Office Action Summary	Application No. 10/595,416	Applicant(s) HERLT, CHRISTIAN	
	Examiner DAVID J. LAUX	Art Unit 3743

DETAILED ACTION

8. Claims 1-2, 4, 6, 8, 10 & 12 are rejected under 35 U.S.C. 103(a) as being unpatentable over US 4,498,909 to Milner et al in view of US 5,901,653 to Jennebach et al, further in view of US 5,720,165 to Rizzie et al and further in view of US 7,228,806 to Dueck et al.

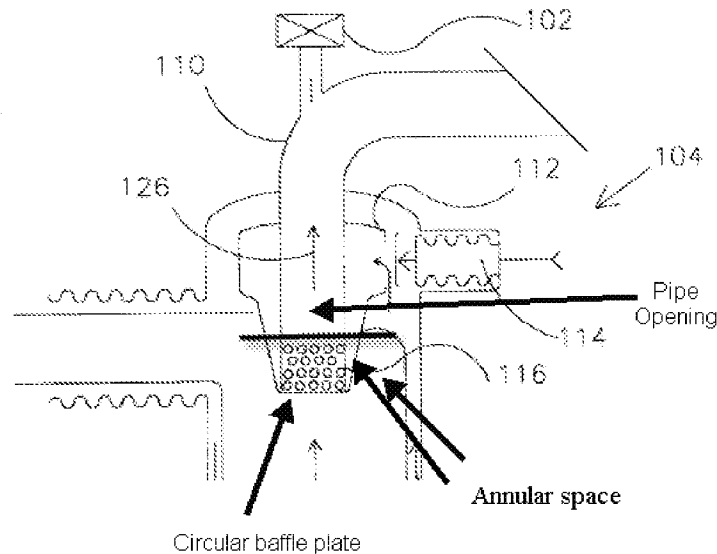
21. With regard to claim 5, '909 as combined with '165 further discloses a circular baffle plate is fitted below the opening of the pipe (see Fig. 6 reproduced in part below) in such a manner that a narrow annular opening ('165: 100) for the depositing of the fine ash particles between an outer wall ('165: 96) of the ash separator ('165: 16) and the baffle plate (centrifugal forces force ash to the outer portion of the separator (the annular space) while allowing clean gases to flow through the pipe).
